Subject: K/J Design Team Responses  
City of Arlington Schematic (10%) Design Review Comments  
K/J 0597002.02

### WWTP and BCF Schematic Design Technical Memorandum

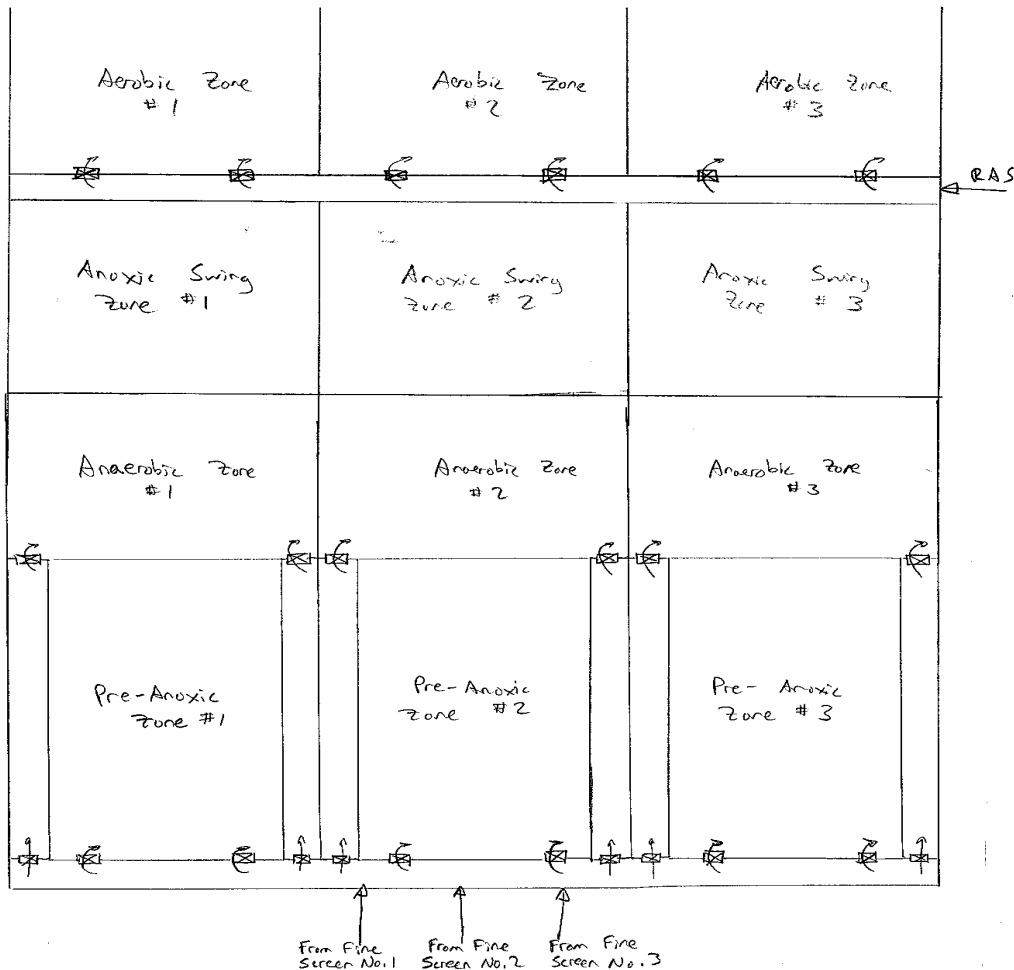
6. Drawing I 202- A flow measuring device of some sort (ultrasonic or velocity or something) would be nice after the slide gate and before the aeration basins; this would be for process control and trouble shooting.

**Response:** The current design is to have a main distribution channel with 2 downward opening weir (slide) gates that will control the flow of influent into the pre-anoxic zone of each aeration basin. The main distribution channel will be sized to create negligible headloss so that flow can be evenly distributed among the aeration basins. There will also be 6 step feed channels off of the main distribution channel (2 per aeration basin, one on each side) to allow influent flow to also be introduced into the anaerobic zone. The step feed channels will be capable of being isolated from the main distribution channel using flush-bottom slide gates when not in use. The flow could be split between the zones or directed entirely to one of the zones by adjusting the weir gates. It is recommended that the gates be operated manually and that staff gauges and position indicators be included for each weir gate so the height of the gate and flow over each gate can be visually compared to confirm a proper balance. Adjustment of these gates should be very infrequent, such that automation of the gates and instrumentation of the flow should not be necessary. Please let us know if you agree with this method of flow distribution.

Similar to the description above, RAS from a common header will be distributed among the aerobic zones using downward opening weir gates off of a main distribution channel. As with the configuration described above, consideration was given to piping the flow directly to each basin, but then balancing the flow becomes much more difficult (requires either manual or automated valve adjustment) and requires flow meters on each distribution pipeline if one membrane tank is out of service, as will be the occasion whenever there is a recovery clean. Therefore, the use of distribution channels with downward opening weir gates is recommended for simplicity and lower cost. A sketch of the proposed distribution channels is shown below.
